M/T - Buzzing/Oil Canning Noises

TSB 08-2-10

4.6L MANUAL TRANSMISSION - SEPARATOR PLATE

2005-2008 Mustang

Figure 1

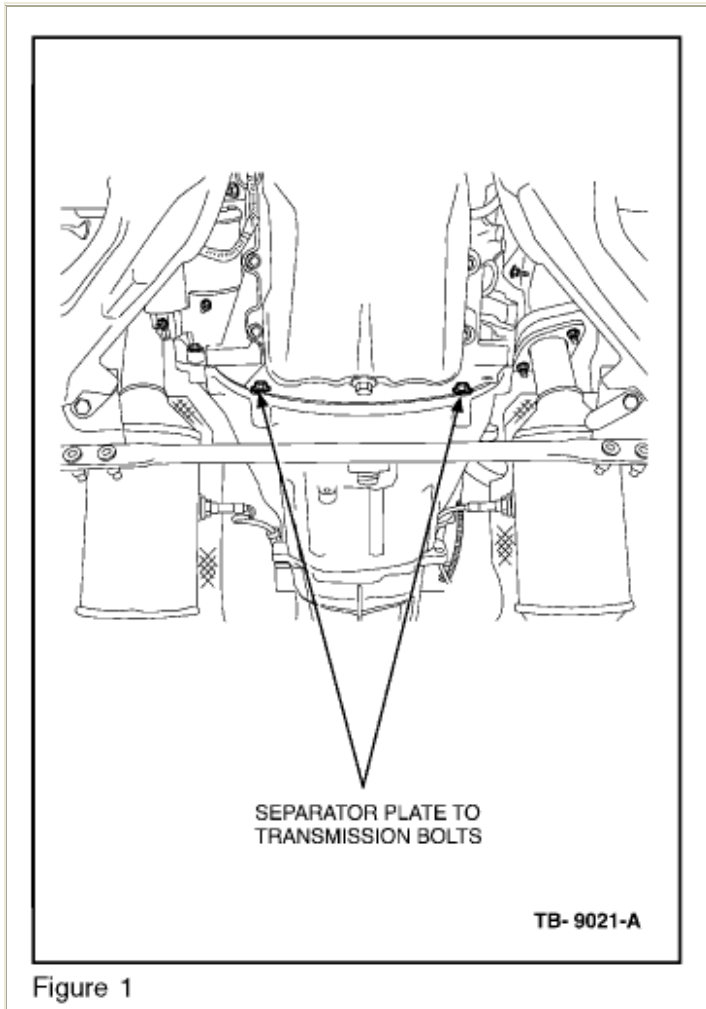
NOTE INSTALL NEW SEPARATOR PLATE TO TRANSMISSION BOLTS IF MISSING OR DAMAGED. (FIGURE 1)
